GOVERNMENT OF THE DISTRICT OF COLUMBIA
OFFICE OF PLANNING

MEMORANDUM

SUBJECT: BZA Application 17327

APPLICATION
1812 35th Street Associates LLC, the applicant, requests a special exception under Section 223.1 to retain a 3-story addition to an existing one-family detached dwelling located at 1812 35th Street, N.W. (Square 1296S Lot 27 [802]) pursuant to Section 3104.1 under Title 11 of the District of Columbia Municipal Regulations (DCMR), Zoning.

AXONOMETRIC OF

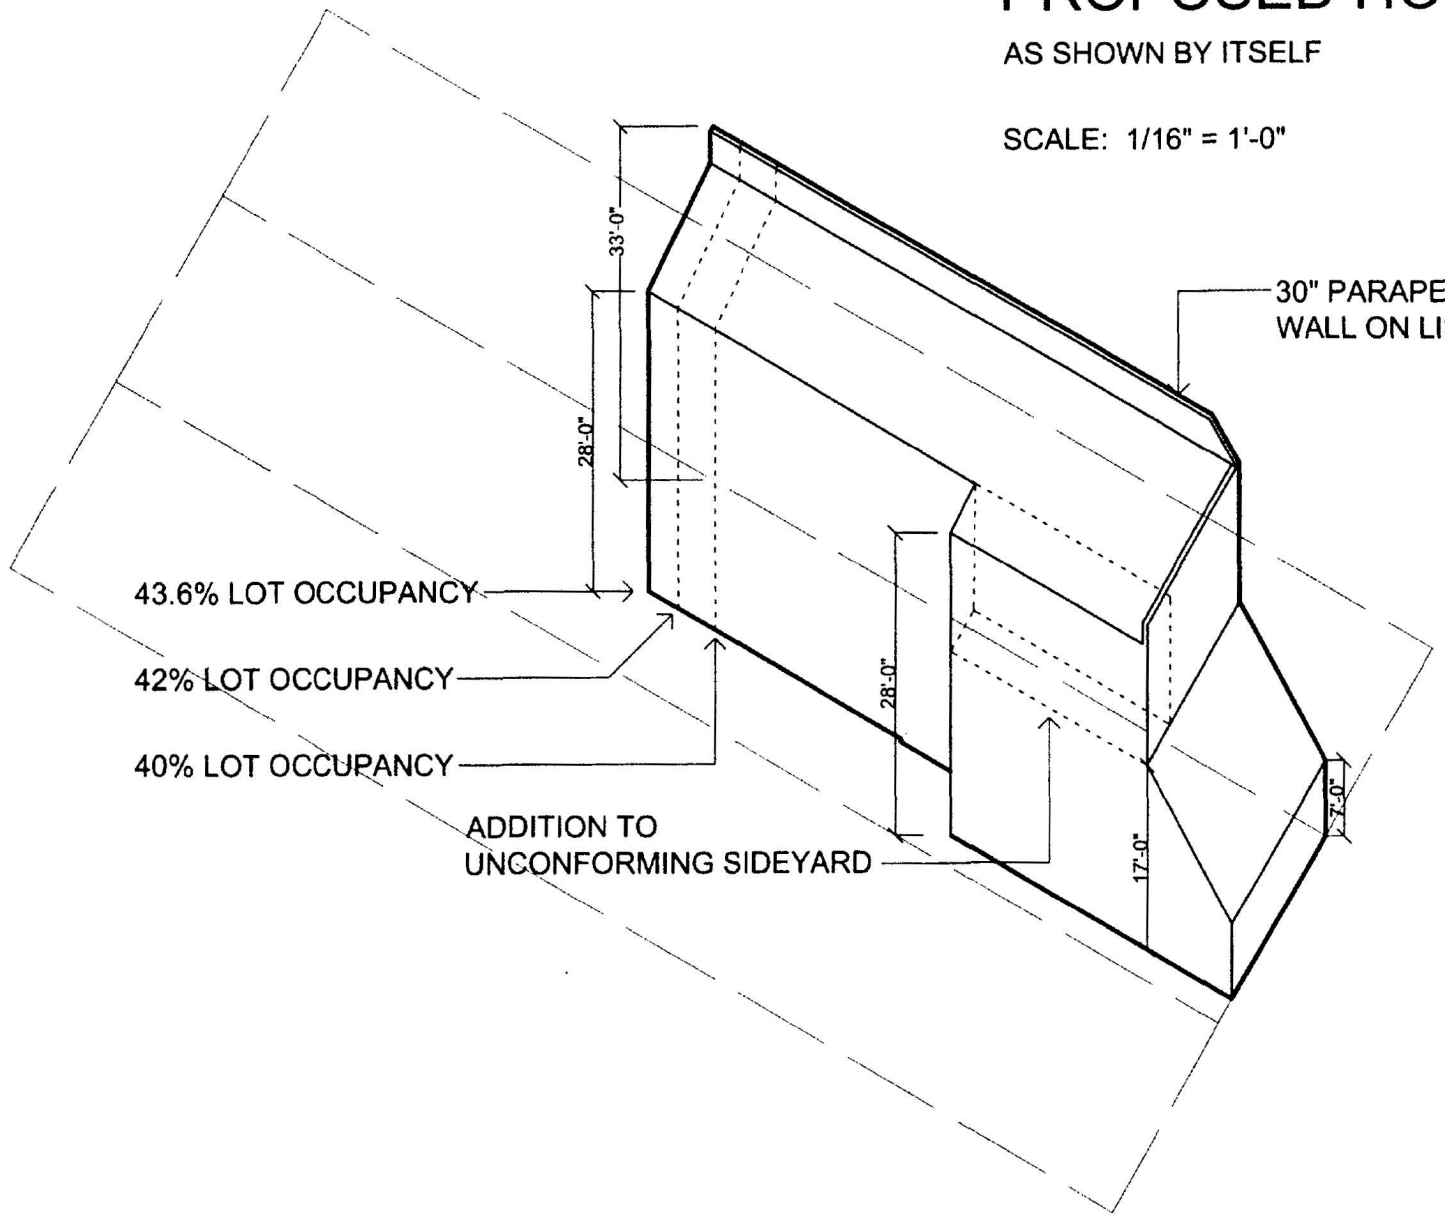
(c) *The addition, together with the original building, as viewed from the street, alley, and other public way, shall not substantially visually intrude upon the character, scale and pattern of houses along the street frontage;* ... The new front façade represents a significant intrusion upon the 35th Street frontage in terms of it's architectural character and scale. Vertical articulation of the second and third floors negates the roofline of the original building while reflecting few characteristics of more typical building facades along the street. A more effective design approach could include bringing the entire façade out to the street, using a sloped roof and dormers at top of the building to make it appear more in scale, and negotiating with Building Code officials to reduce or eliminate the additional 3 feet of wall height required for the northern firewall.

RECOMMENDATION
The Office of Planning (OP) cannot support approval of this request because the application does not meet the standards of Section 223.1. OP encourages the applicant to reduce the height of the addition, and redesign the front façade to be more in scale and character with the existing pattern of dwelling facades along 35th Street.

SHADOWS OF

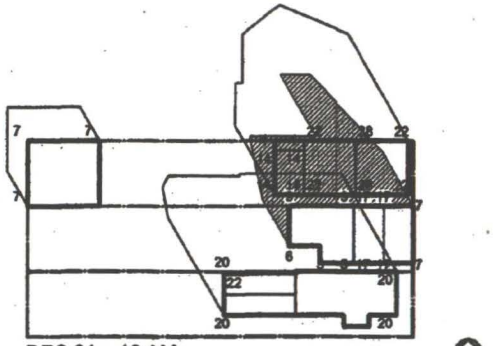
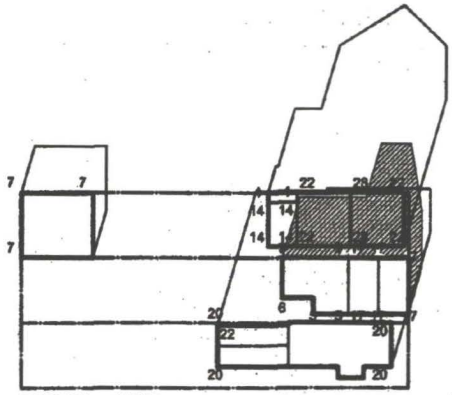
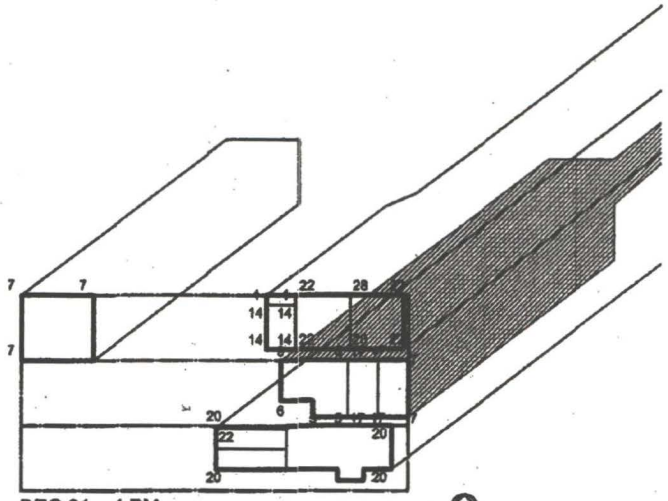
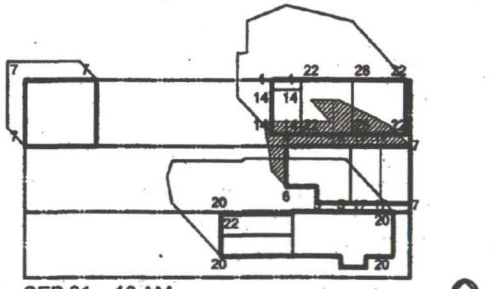
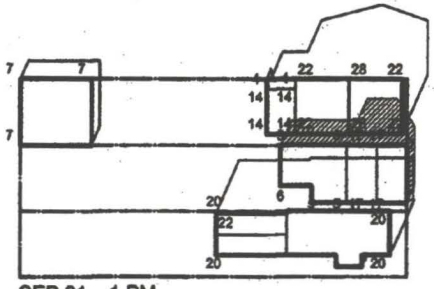
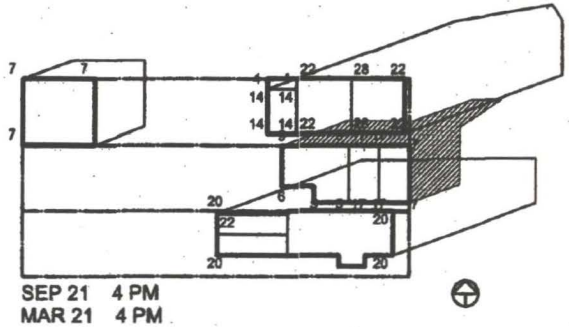
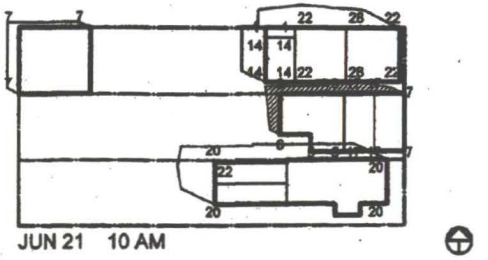
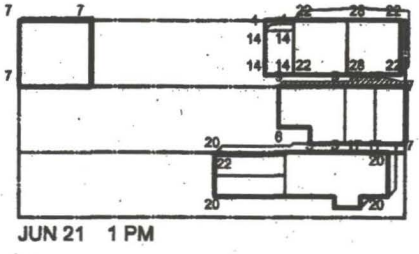
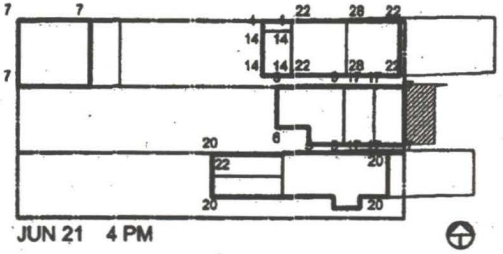
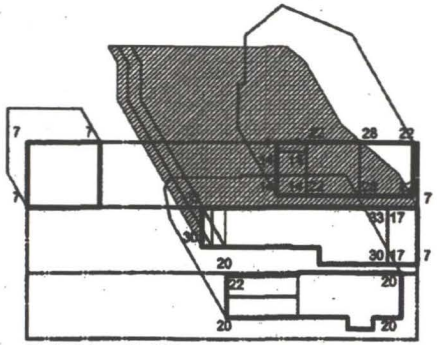
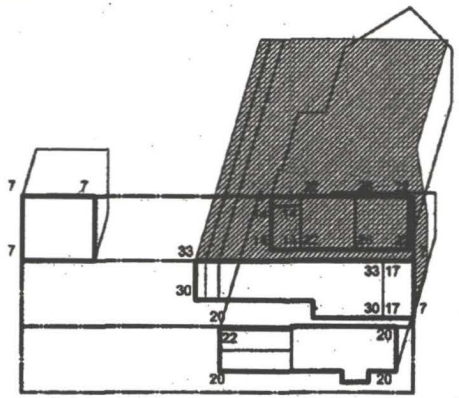
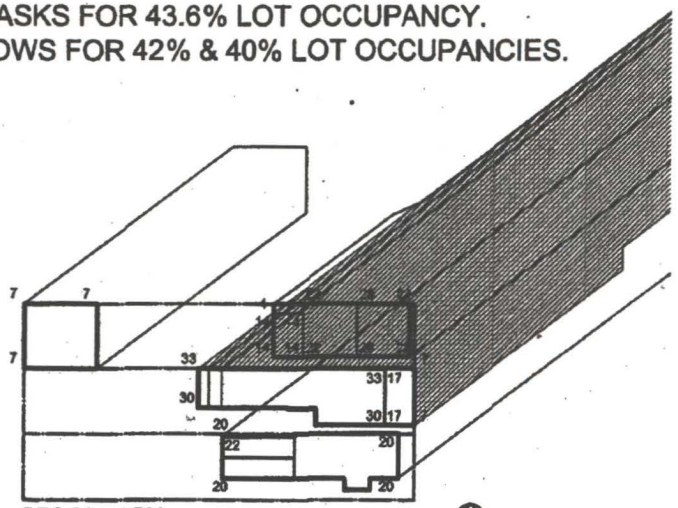
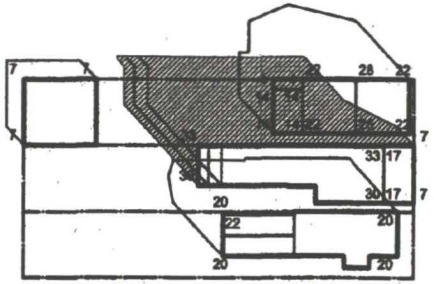
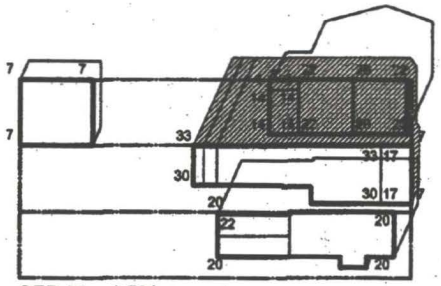
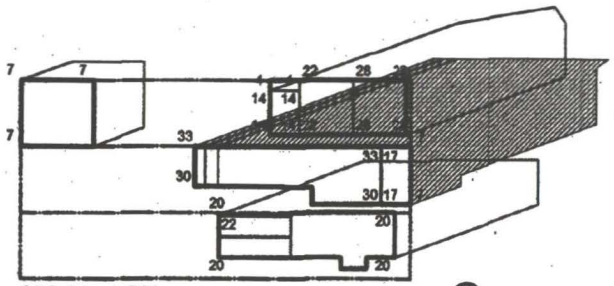
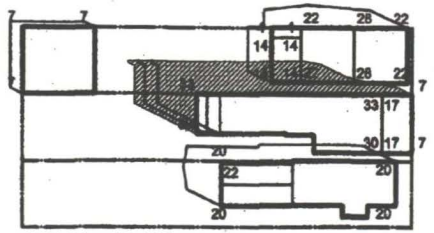
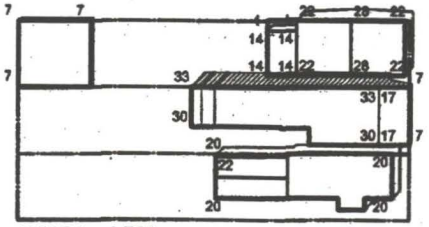
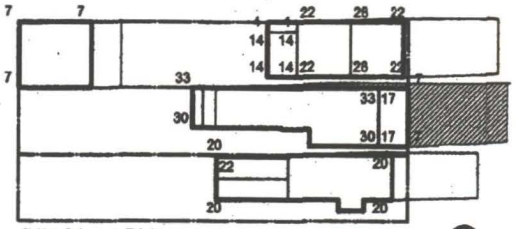
(a) *The light and air available to neighboring properties shall not be unduly affected;* The proposed addition does not affect the air available to neighboring properties, however it significantly changes how shadows are cast on properties to the north. At OP's request, the applicant's architect prepared shadow diagrams approximating the original conditions, the dwelling with the addition, and the dwelling with theoretical maximum (4-foot wide) addition allowed under the Zoning Regulations (refer to Exhibits 4-9).

These diagrams indicate that shadows cast by the current construction or the original dwelling with a theoretical matter-of-right addition will (would) cover more of adjacent rear yards for a longer period from early fall through the winter. Under either option, the neighboring dwelling at 1814 35th Street largely remains in shadow most of the day during this period. Note that the "Shadows of Existing House" diagram (Exhibit 8) also seems to indicate that reducing the existing addition to 1-story would still cast a shadow over the abutting rear yard in the winter.

Diagrams also indicate that the new construction will not affect the neighboring properties to the south, and, because the adjacent 35th Street right-of-way is 80 feet wide, it does not appear the new shadow pattern will affect properties on the opposite side of the street.

OP is less concerned about shadows cast on the neighboring dwelling(s) to the north than about how those shadows may affect the utility of the rear yards. The applicant is encouraged to consider "stepping-down" the height of the addition to one story for that portion that extends beyond the original dwelling. This would mitigate the extent and duration of shadows cast in the fall months. Unless these or other effective mitigation measures are proposed, OP cannot conclude the light available to abutting properties is not substantially adversely affected.

223.4 *The Board may require special treatment in the way of design, screening, exterior or interior lighting, building materials or other features for the protection of adjacent and nearby properties.* OP recommends that applicant consider reducing the height of the addition, particularly the portion that extends beyond the original dwelling. They should also consider redesigning the front façade to be less intrusive and reflect more characters of the surrounding architecture.
